Access Compliance Report

Public Rights-of-Way

Intersection ID: 10039533	Main Street: TEXLAND_BV	Cross Street: N/A	Location: SE
ADA ID: 7A14A2F38DF7	Ramp Type: PerpDiag	Initial Pass/Fail: Fail	Overall Compliance: No
		Severity Score: 12.5

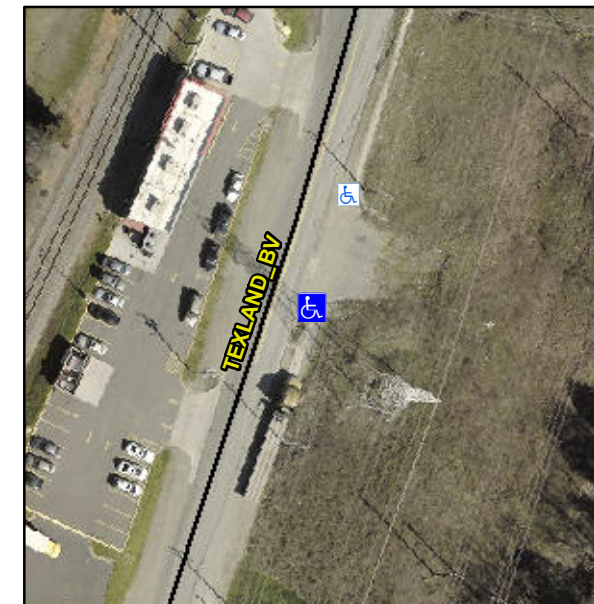
Not Found, R304.2.2

Compliance	Description	Data	Compliance	Description	Data
N/A	Ramp Length (in)	48.0	No	Ramp Slope (%)	10.1
Yes	Ramp Width (in)	48.0	Yes	Ramp XSlope (%)	1.2
N/A	Flare Type LT	N/A	N/A	Flare Type RT	N/A
N/A	Flare Slope LT (%)	N/A	N/A	Flare Slope RT (%)	N/A
N/A	Flare Traversable LT?	N/A	N/A	Flare Traversable RT?	N/A
N/A	Landing Length (in)	N/A	N/A	DWS Provided?	N/A
N/A	Landing Width (in)	N/A	N/A	DWS Contrast?	N/A
N/A	Landing Slope (%)	N/A	N/A	DWS Length (in)	N/A
N/A	Landing X Slope (%)	N/A	N/A	DWS Full Width?	N/A
N/A	Landing Curb? (Y/N)	N/A	N/A	DWS Offset (in)	N/A
N/A	Shared Landing?	N/A			
N/A	Gutter Ponding?	N/A	N/A	Gutter Slope (%)	N/A
N/A	Gutter Lip Ht (in)	N/A	N/A	Gutter X Slope (%)	N/A
N/A	Painted X Walk1?	No	N/A	Painted X Walk2?	No
	X Walk 1 Direction	To N		X Walk 2 Direction	To W
N/A	X Walk 1 Width (in)	N/A	N/A	X Walk 2 Width (in)	N/A
	X Walk 1 Slope (%)	0.8		X Walk 2 Slope (%)	0.8
	X Walk 1 X Slope (%)	1.2		X Walk 2 X Slope (%)	0.3

Remove & Replace Curb Ramp With Two New Directional Ramps or Equivalent.
